Preliminary Plan Application for Church and Adult Day Care Use on 28.22± Acres in the RC Zone

**Re: Preliminary Plan 120240050, Korean Mission Church, 1201  
Ashton Road, Ashton, Maryland**

**DATE:** 28-Oct-24  
**TO:** Dhaval Patel - dhaval@vanmar.com  
Vanmar Associates, Inc  
**FROM:** Marie LaBaw  
**RE:** Korean Mission Church  
120240050

**MNCPPC PRELIMINARY PLAN NO. 120240050**

**FIRE DEPARTMENT ACCESS PLAN**

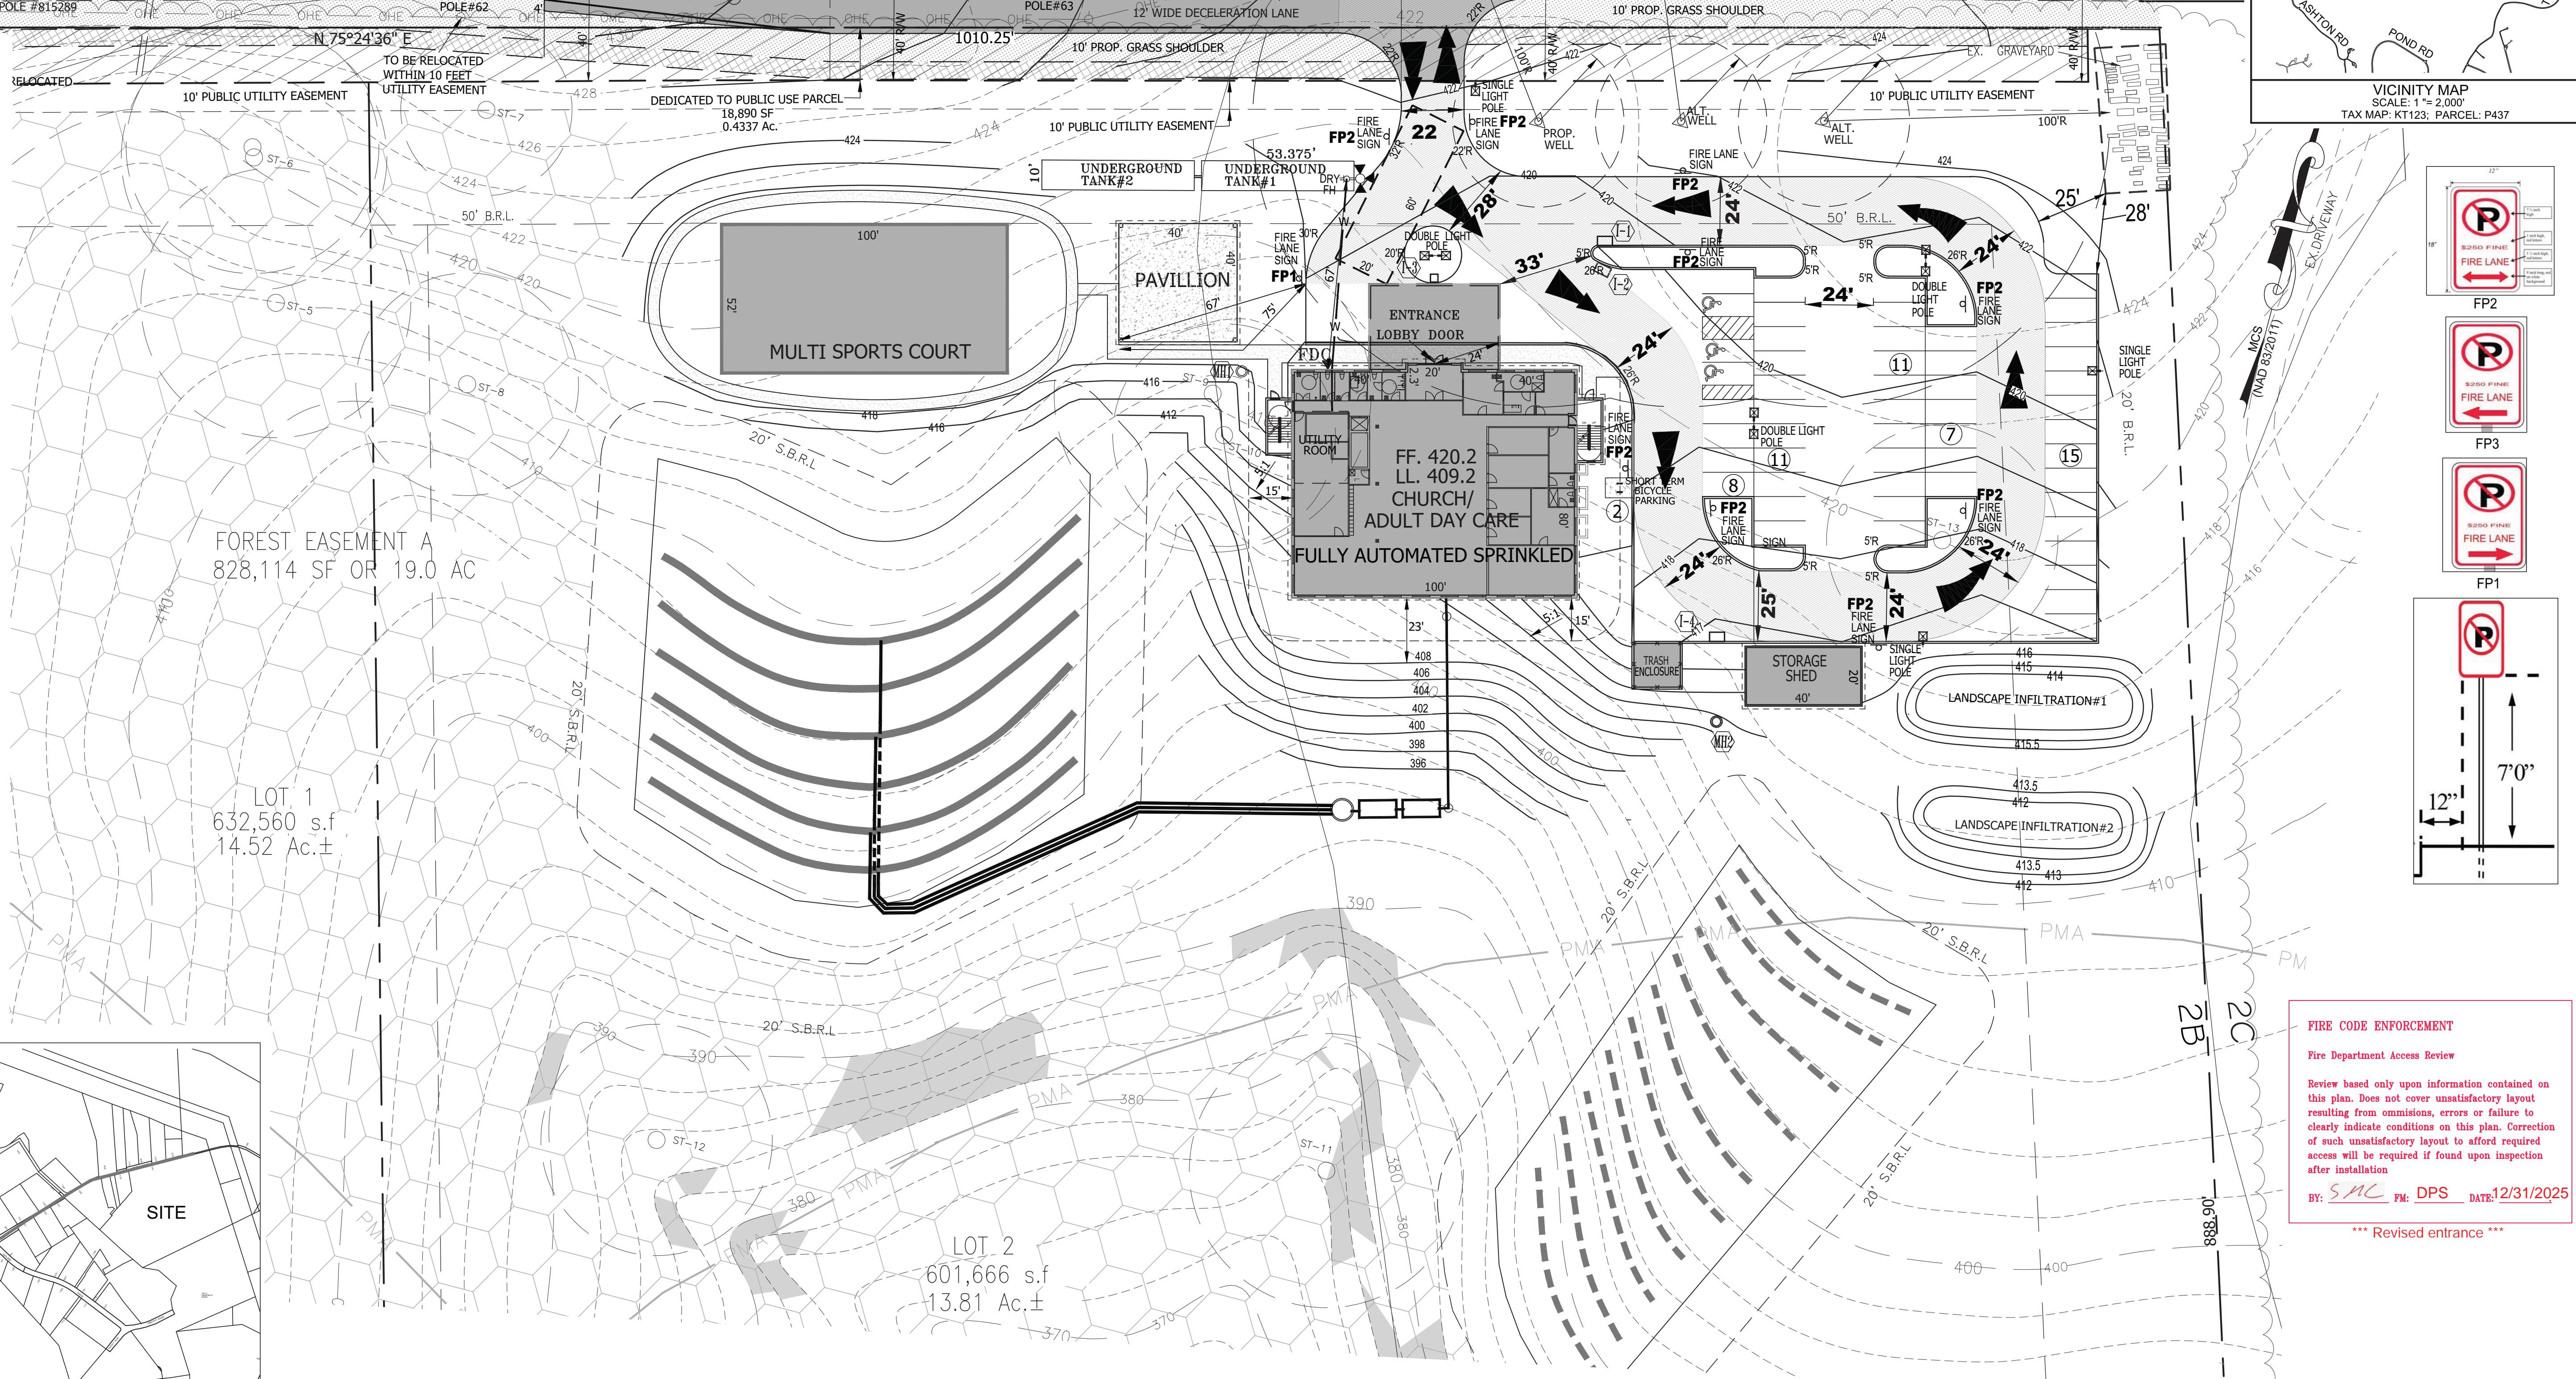
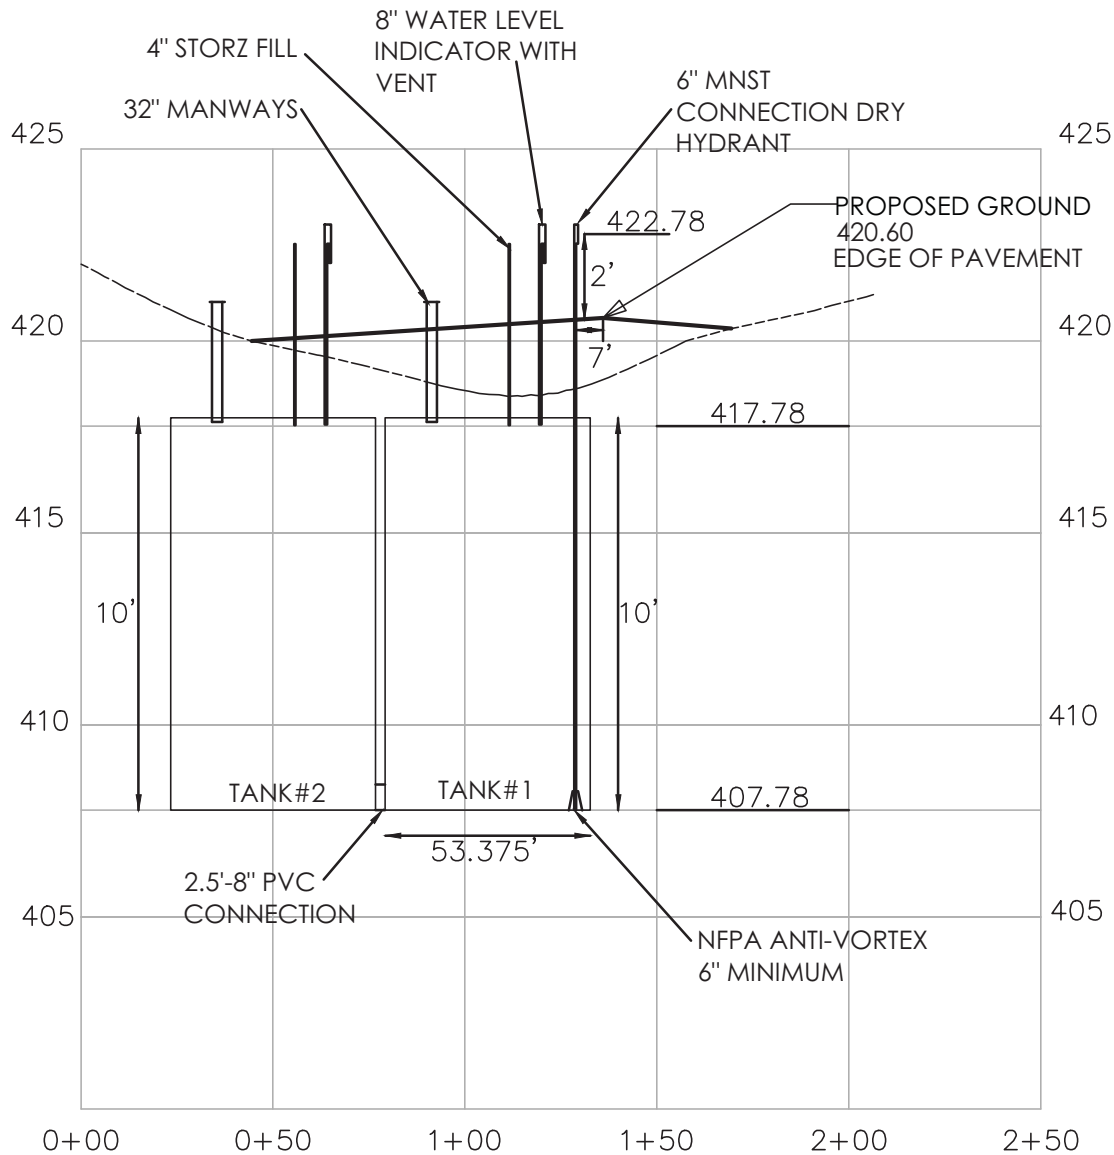
**\*\*\* 12/31/2025 Revised entrance \*\*\***

\*\*\* Revised entrance \*\*\*

NOTE:  
 THE UNDERGROUND TANK AND FIRE HYDRANT DESIGN WILL BE REVIEWED BY DPS FIRE PROTECTION SYSTEM PLAN REVIEW GROUP AT TIME OF BUILDING PERMIT PROCESS.
